PERMIT

SEWAGE DISPOSAL SYSTEM

SUBDIVISION Florence Estates ROAD 2075 Florence Road LOT 12

PLOT PLAN
 LOT 12, SECTION 2
 FLORENCE ESTATES
 2075 FLORENCE ROAD
 FOURTH ELECTION DISTRICT
 HOWARD COUNTY, MARYLAND

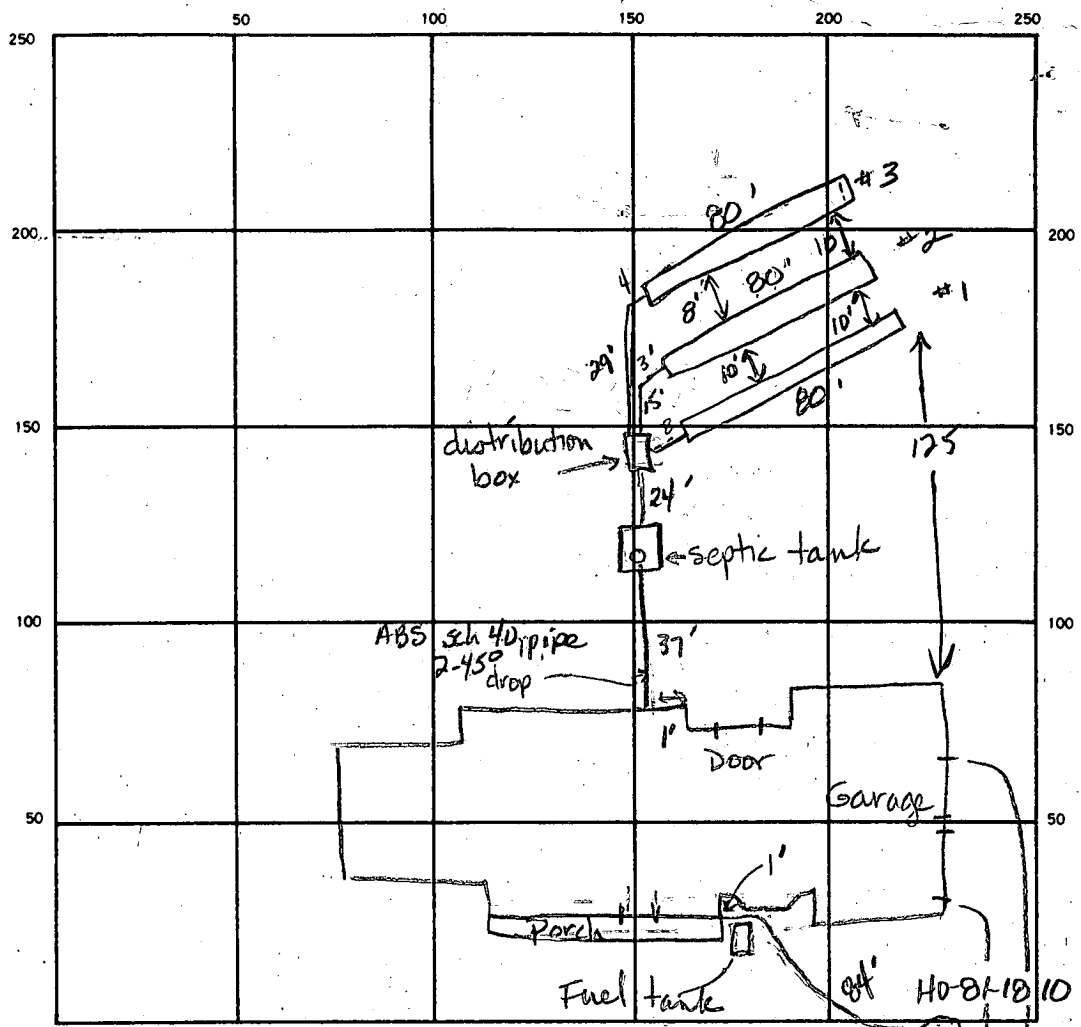
REMARKS 11-10-88 Extend trench # 2 to 80 ft. OK to add stone to all trenches. Add cleanout to septic tank and a baffle to the distribution box. JEN
OK to cover all work. JEN

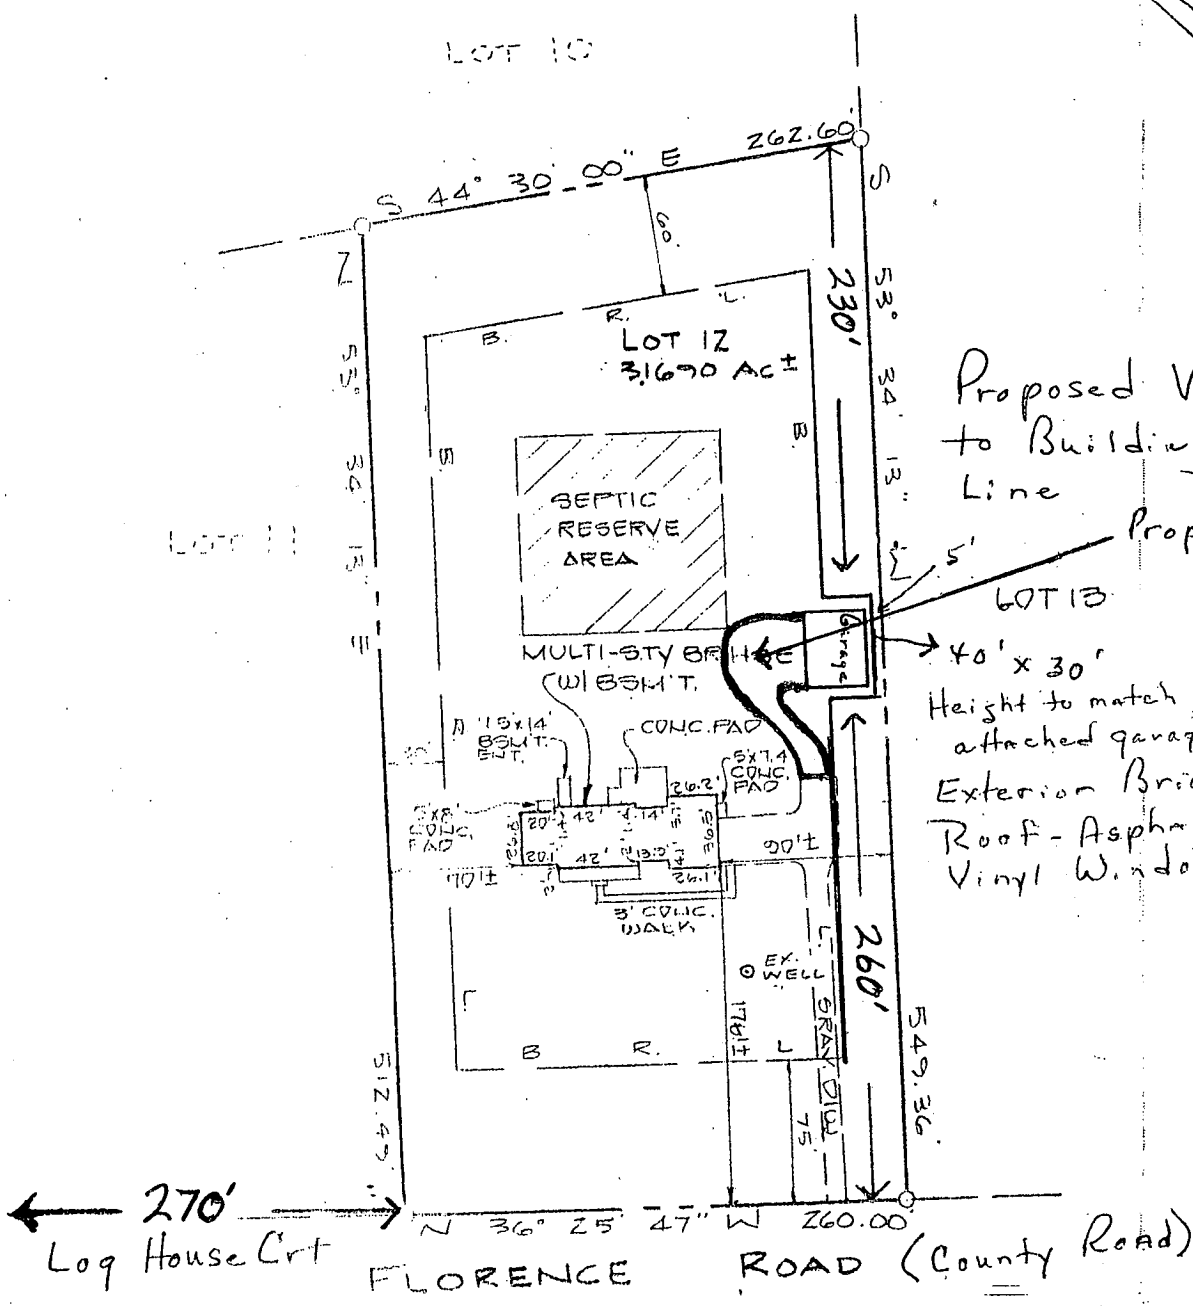
- A. PROPOSED HOUSE (NO BSMT. FACILITIES)
 F.F. El. = 683.0 ✓
 Bsmt. El. = 674.5 ✓
 Inv. Out = 677.04 ✓ (BSMT)
- B. PROPOSED SEPTIC TANK
 Ex. El. = 681.25 ✓
 Inv. In = 677.27 ✓
 Inv. Out = 677.07 ✓
- C. PROP. DISTRIBUTION BOX
 Ex. El. = 680.0 ✓
 Inv. In = 676.07 ✓
- D. PROPOSED TRENCHES
 3 @ 80' (length) ✓
 Inv. El. = 676.5 ✓
 1 1/2' of stone ✓
 5' bottom max. ✓

6/8/88
 elevations
 ok SM
